**ADDENDUM # 2**

<b>Project</b>	TA Blakelock High School Renovations	<b>Project No.</b>	2215-B
<b>Location</b>	1160 Rebecca Street, Oakville, ON	<b>Date of Issue</b>	2024 04 19
<b>Owner</b>	Halton District School Board	<b>File</b>	2215/7.1.3

This Addendum forms part of the Contract Documents and amends the original Drawings and Specifications, dated 2024 04 11, and all preceding Addenda, as noted below.

**3 SCIENCE/PHYSICS CLASSROOM RM E104**  
 A102 1:50

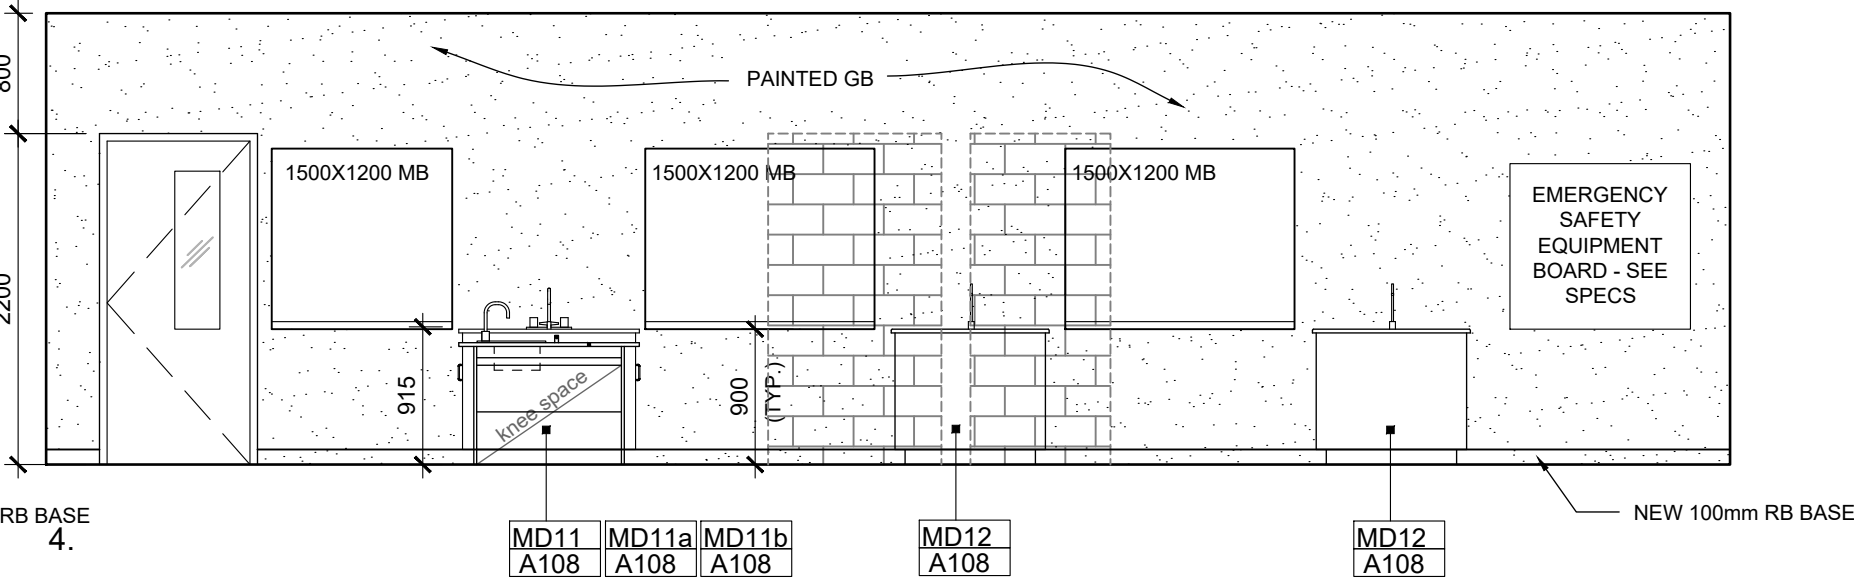
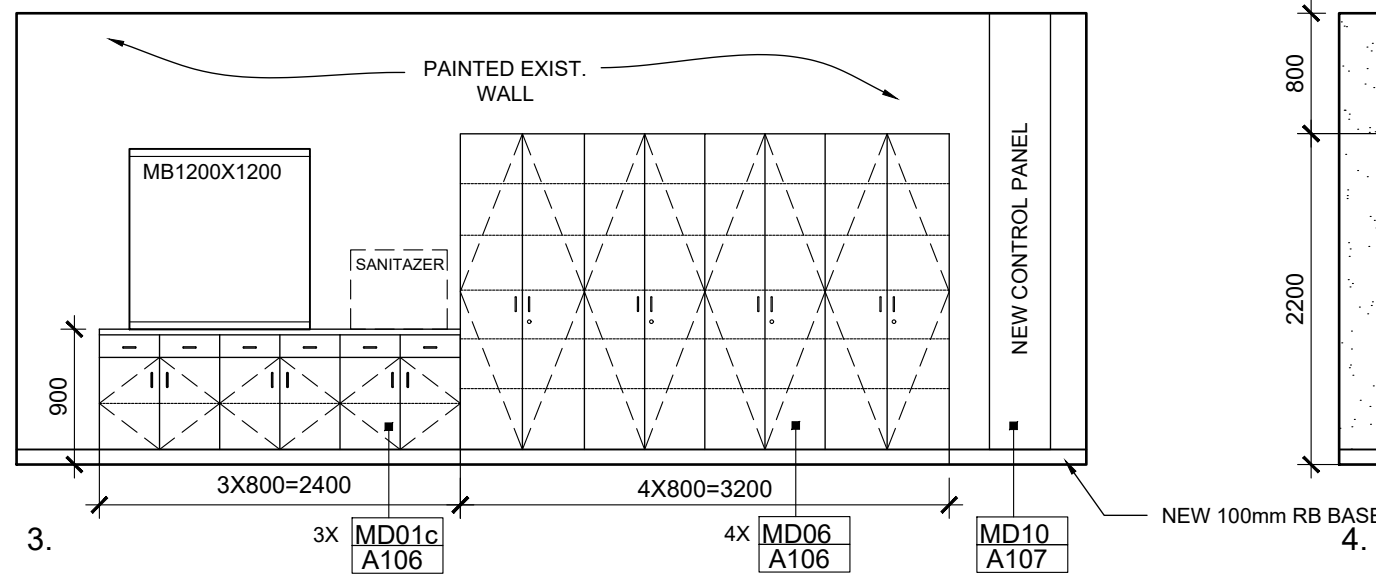
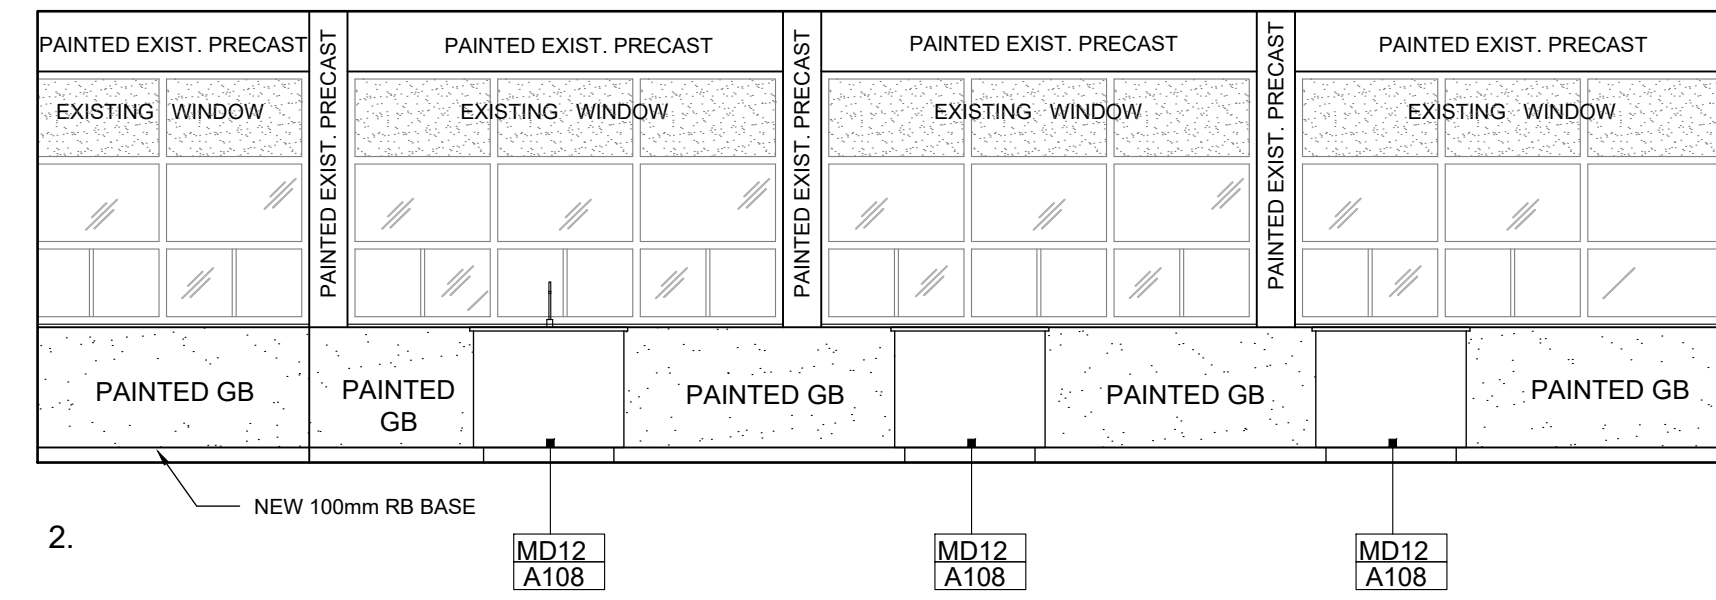
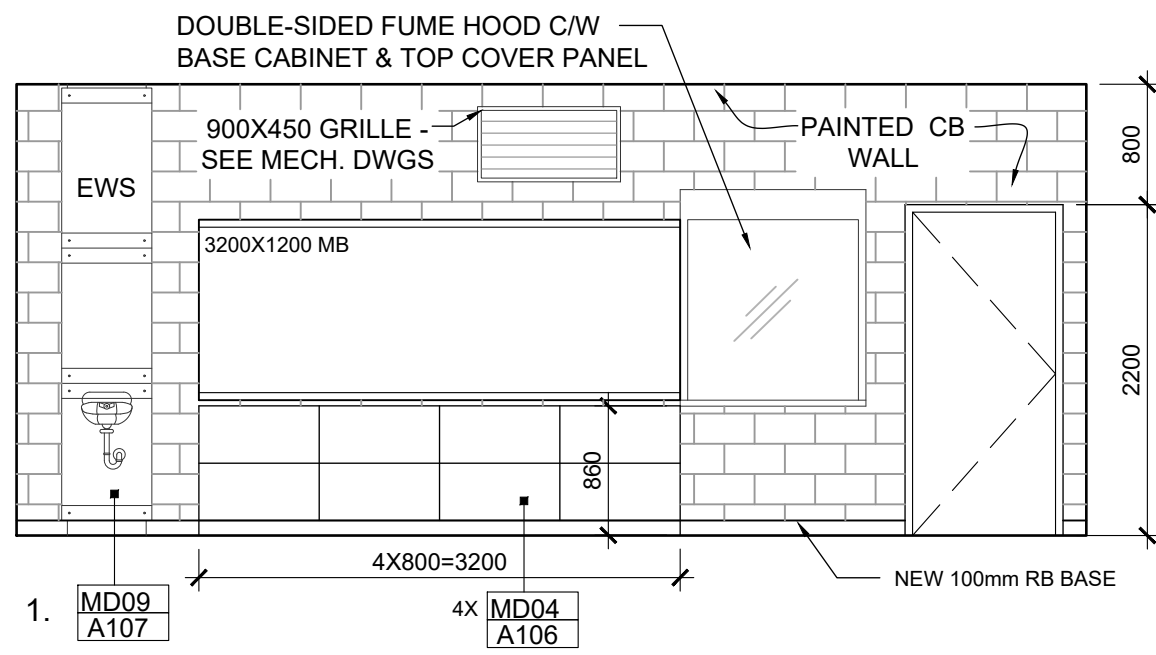
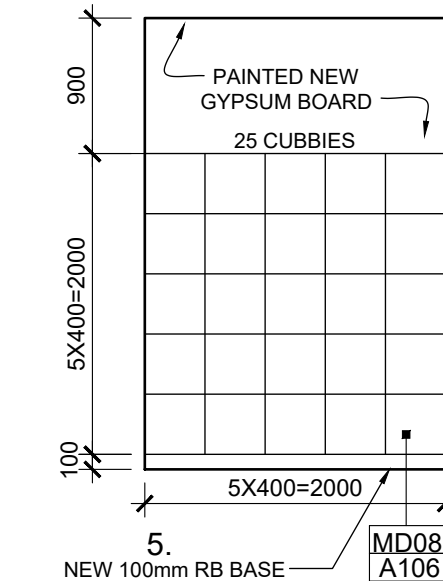
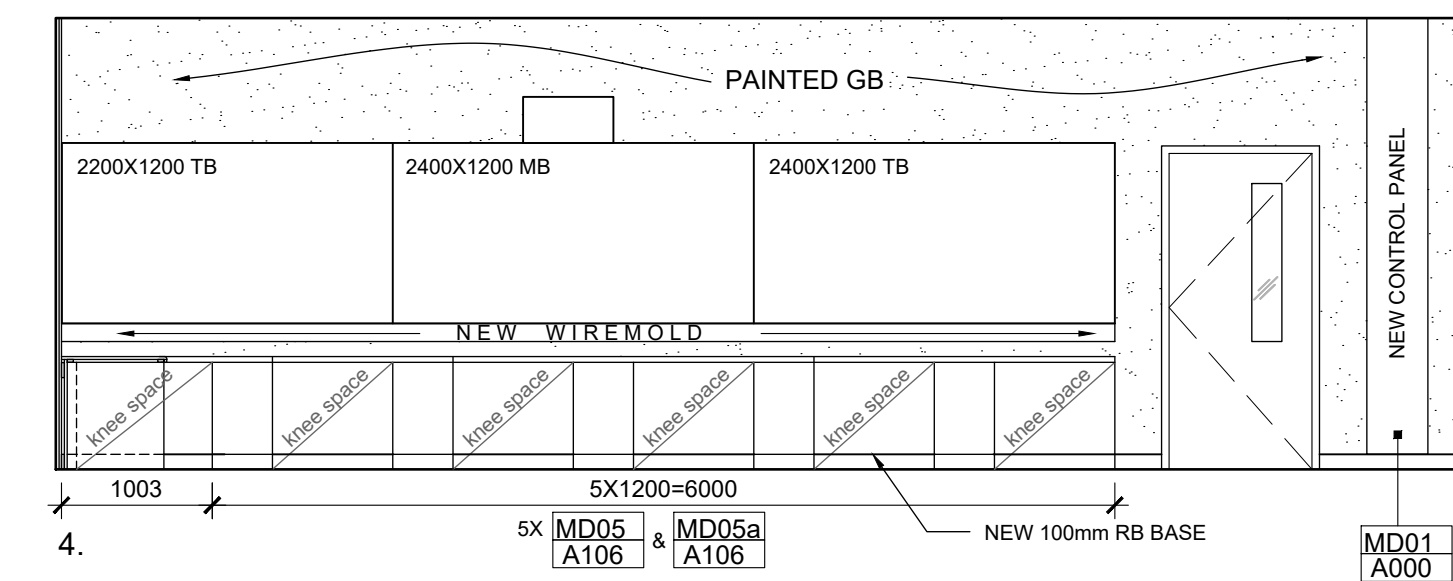
**A2-1 ARCHITECTURAL DRAWINGS****1. Drawing A102 Interior Elevations**

.1 Millwork reference changed on Elevation 1 on Drawing 3/A102.

1 CHEMISTRY CLASSROOM RM E117  
A103 1:50

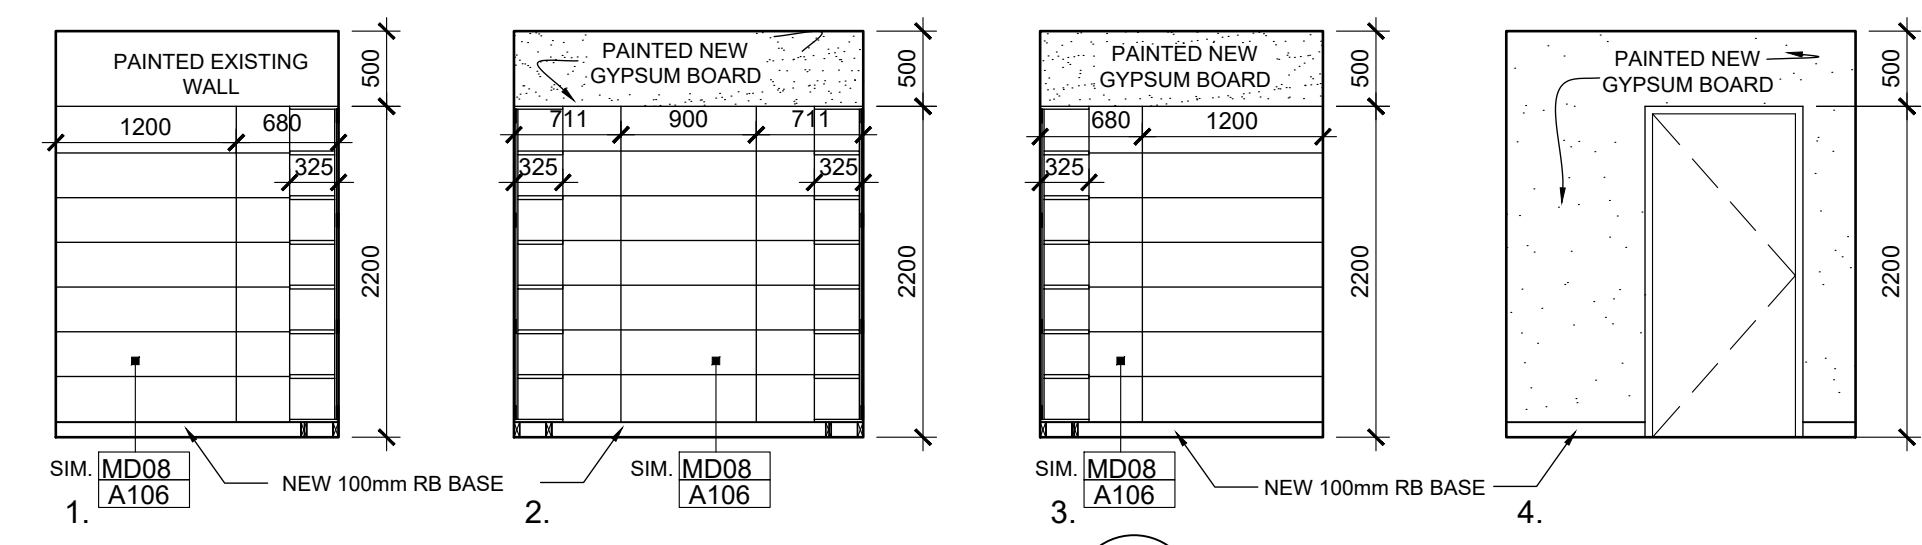
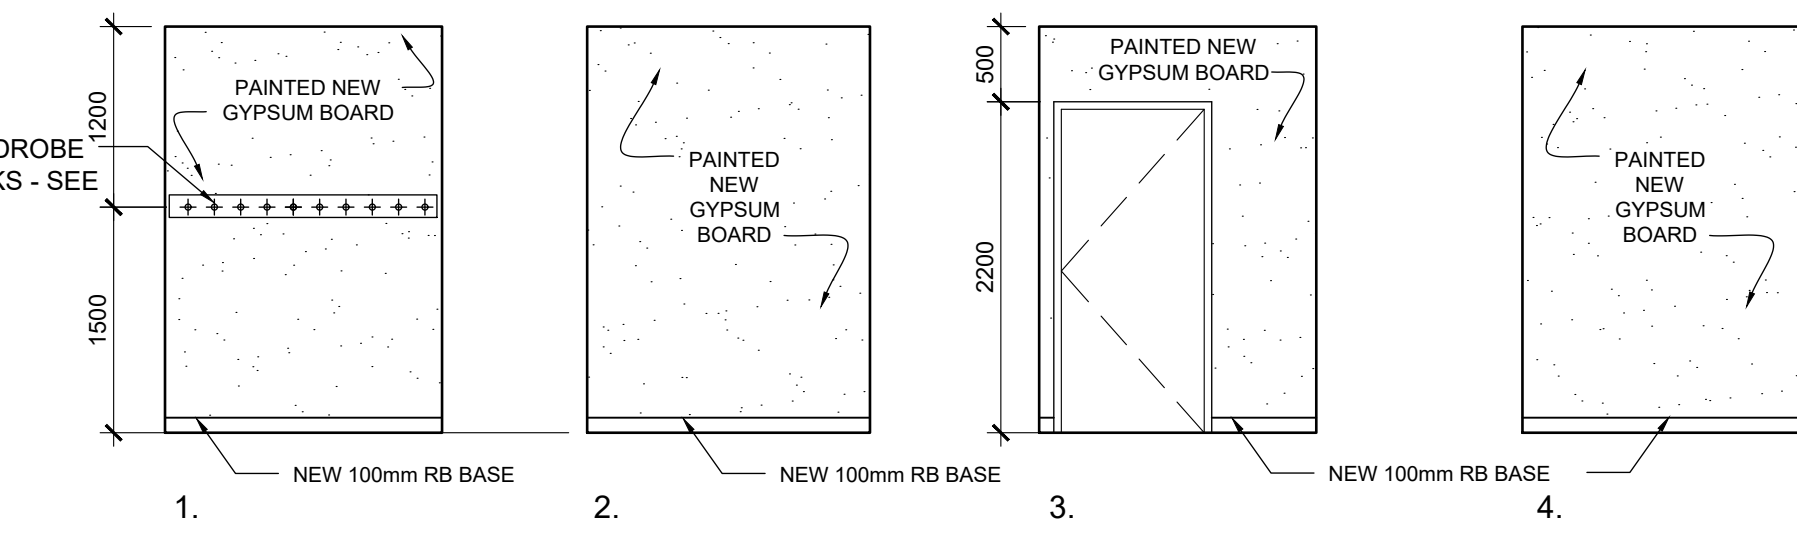
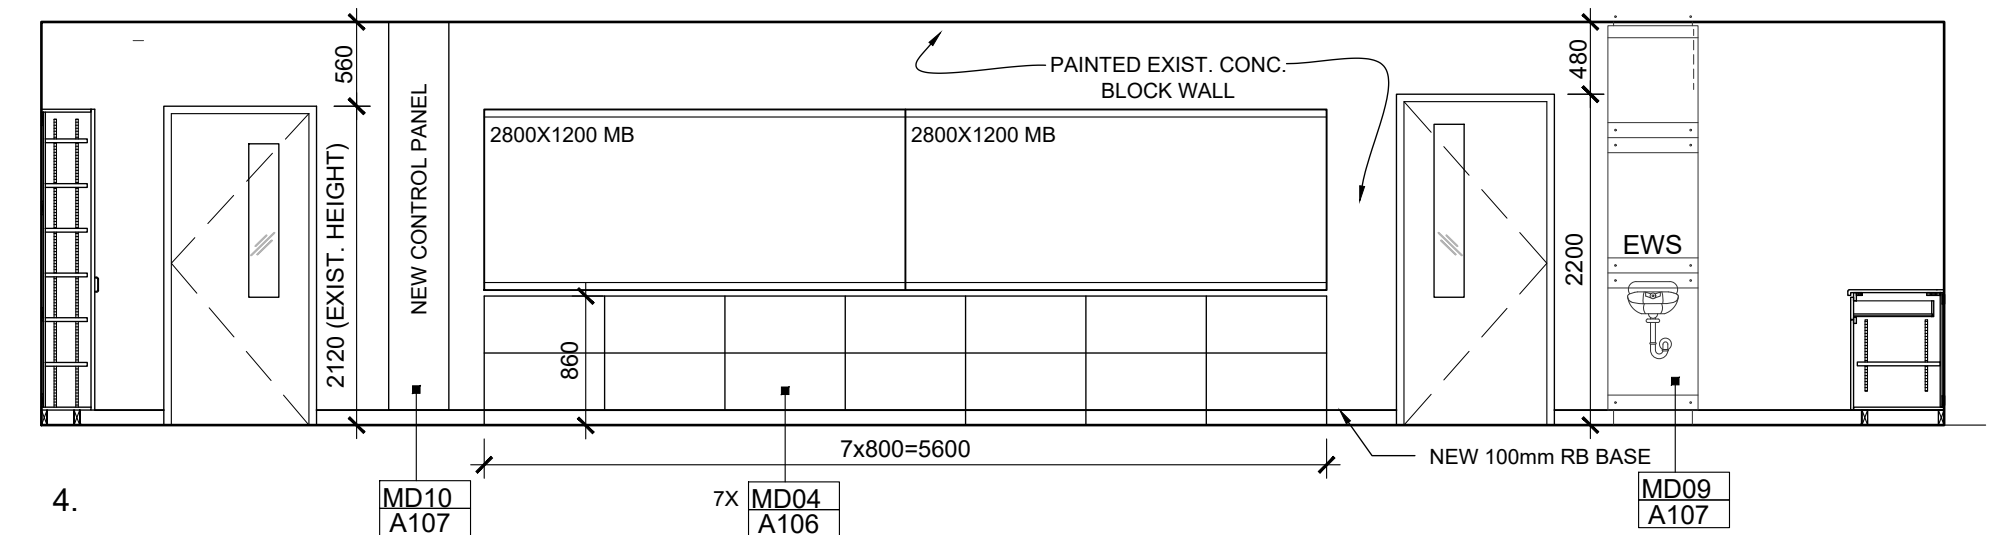
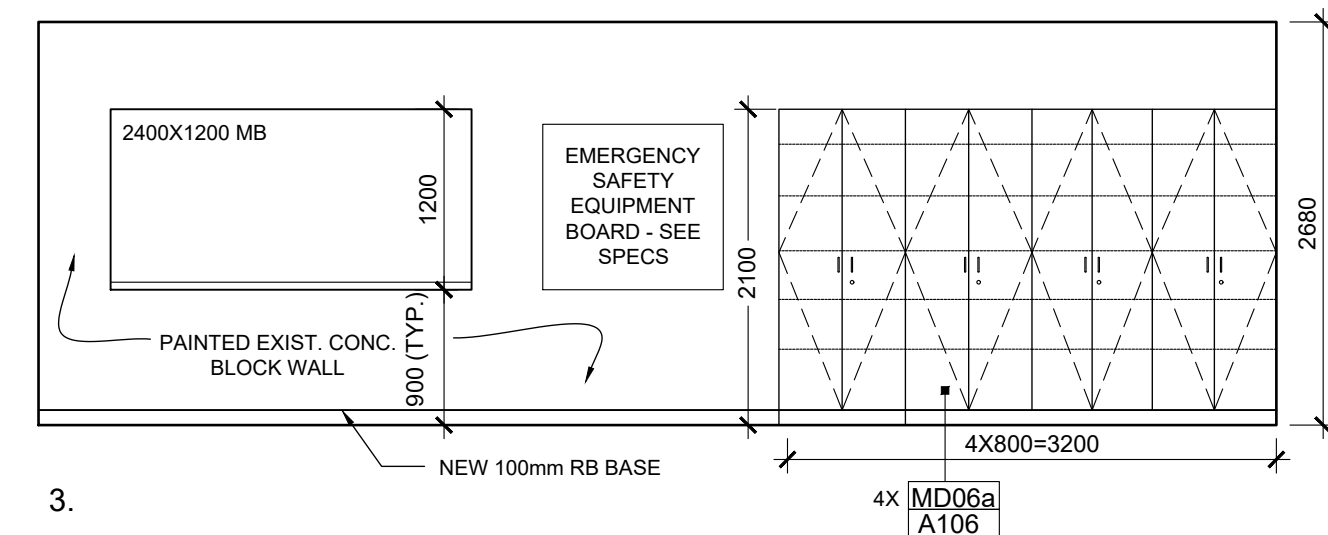
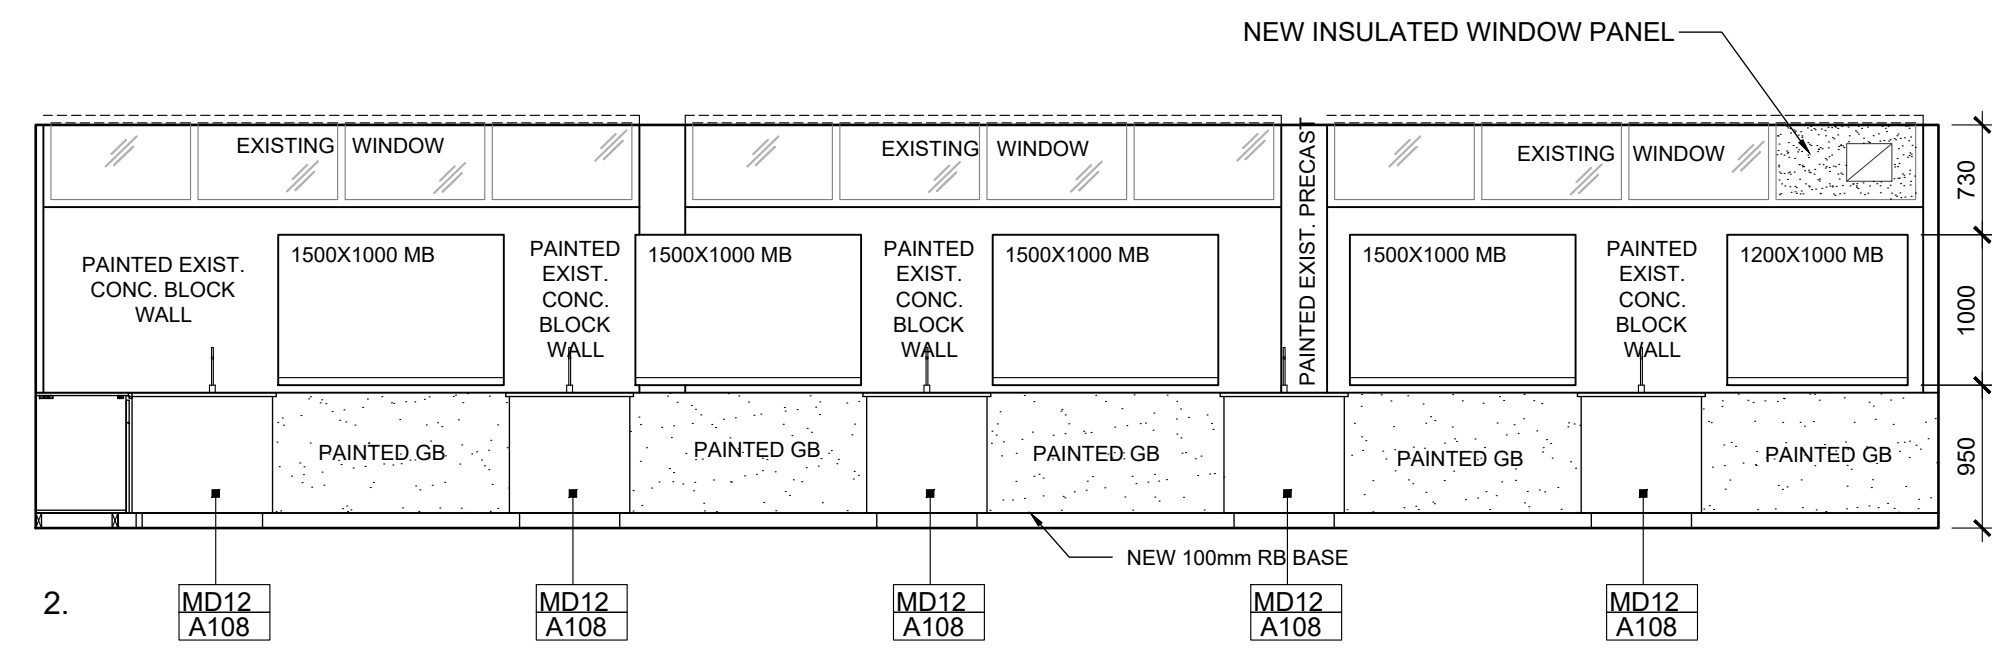
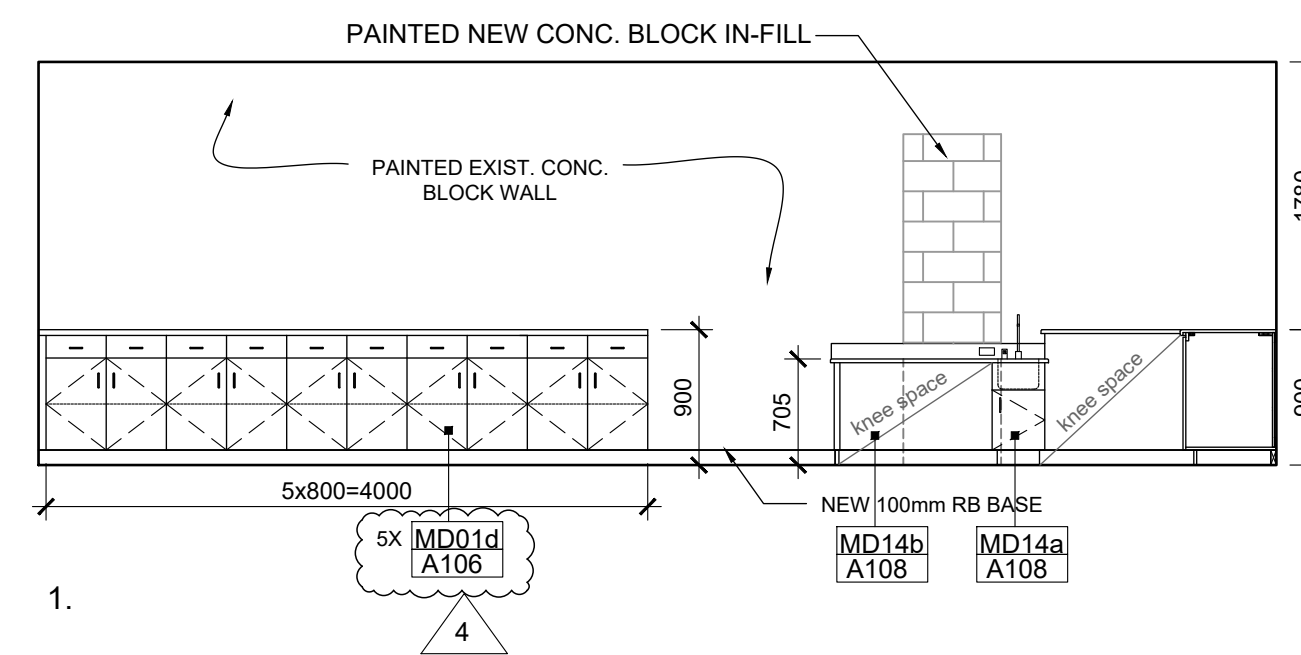
**2. Drawing A103 Interior Elevations**

.1 Millwork reference changed on Elevation 1 on Drawing 2/A103.
